CENTRAL PARK

AMENDED PLANNING APPLICATION (2)

| Title: | OVERALL BUILDING CHANGES |
| Dwg No: A-PA-OA-149 | Revision: H |

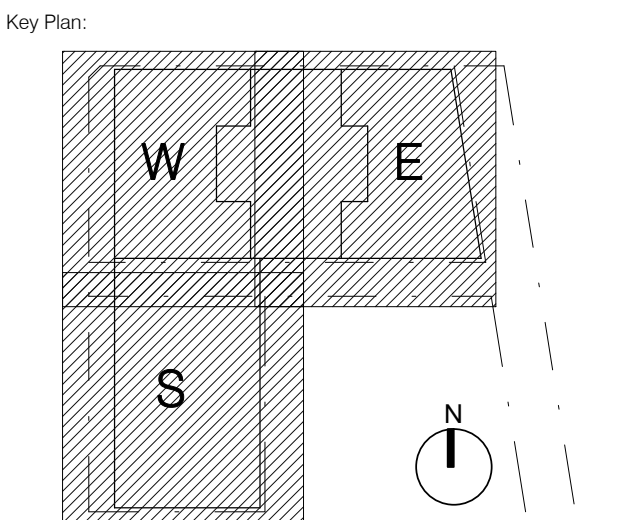
- B-01** SUPERMARKET AREA INCREASED.
- B-02** POSITION OF GREEN WALL REVISED.
- B-03** NEW EGRESS ADDED.
- B-04** RETAIL AND RETAIL ARCADE SHAPE AND AREA MODIFIED.
- B-05** RETAIL AREA INCREASED.
- B-06** TERRACE REMOVED AND OPEN SPACE REDESIGNED.

- P-01** BROADWAY AND BALFORE ST GLAZED AWNING RAISED FROM L1 TO L2 DATUM LINE.
- P-02** GLAZED AWNING ADDED TO KENT ST L2 TO MATCH BROADWAY AND BALFORE ST.

- P-03** NOT APPLICABLE.
- P-04** GREEN WALLS ADJUSTED TO BROADWAY, BALFOUR, KENT ST TO SUIT AWNING HEIGHT CHANGE AND SIGNAGE ZONE ADJUSTMENTS.
- P-05** KENT ST GND TO L1 FRONTAGE FACADE ADJUSTED TO SUIT APARTMENT ENTRY DESIGN.

- P-06** INTERNAL GFA ADJUSTMENTS DUE TO SERVICES, RETAIL AND ATRIUM VOID CHANGES FROM B1 TO L4.
- P-07** CAR PARK EXHAUST RISER RELOCATED AND MAIL ROOM ADDED TO HIGHRISE LOBBY.

- P-08** LOWER COURTYARD - EAST AWNING INCREASED IN DEPTH AND WEST AWNING CHANGED TO CANTILEVER PLANTER AWNING.
- P-09** LOWER COURTYARD - WATER FEATURE DELETED AND LANDSCAPING ADJUSTED TO SUIT WITH CENTRAL PATHWAY AND ADDITIONAL TREES.

- P-10** CHANGING SLAB EDGE PLANTERS TO POP-UP PLANTERS ON SOUTH SIDE TO MATCH OTHER POP-UP PLANTERS.
- P-11** INTERNAL VOID AND STAIR CONNECTING L2 AND L3 REMOVED.

- P-12** 2 INTERNAL ESCAPE STAIRS INCREASED TO SUIT BCA REQUIREMENTS.
- P-13** L5 RECREATION TERRACE INTRODUCTION OF CABANA SHADE STRUCTURES AND ADJUSTMENT OF LANDSCAPING.

- P-14** AWNING SIZE INCREASED
- P-15** SOUTHERN PODIUM CANTILEVERED TERRACES AND PLANTER.
- P-16** GLAZED AWNING GLASS PATTERN CHANGED

- TE-01** L32 TO L33 FLOOR TO FLOOR HEIGHT REDUCED BY APPROX. 115MM, OVERALL BUILDING HEIGHT UNCHANGED.
- TE-02** L29 TO L33 APARTMENT PARTY WALL POSITIONS AND TERRACES ADJUSTED. NUMBER AND MIX OF APARTMENTS NOT CHANGED.
- TE-03** CANTILEVER STRUCTURE EXPOSED FRAME ALTERED TO REDUCE BULK AND EXTENT OF ENVELOPE.
- TE-04** LOGGIAS CONVERTED TO BE PART OF INTERNAL APARTMENT - EXTERNAL FACADE LINE UNCHANGED.
- TE-05** CANTILEVER REFLECTORS MODIFIED.
- TE-06** MINOR CHANGE TO POP-OUT LOCATION

- TW-01** L16 PERIMETER LANDSCAPING, TERRACE AND BALUSTRADES ADJUSTED.
- TW-02** L17 HELEOSTAT MIRRORS NUMBER REDUCED TO 40.
- TW-03** L17 PARKED BMU HEIGHT INCREASE AND ADJACENT PLANT ROOM HT INCREASE TO MAINTAIN SCREENING.
- TW-04** INTERNAL LIFT ADDED TO LINK LEVEL 04 AND LEVEL 05 (GYM/ EXTERNAL RECREATIONAL TERRACE). DISSABLED STAIR LIFT ALSO ADDED.
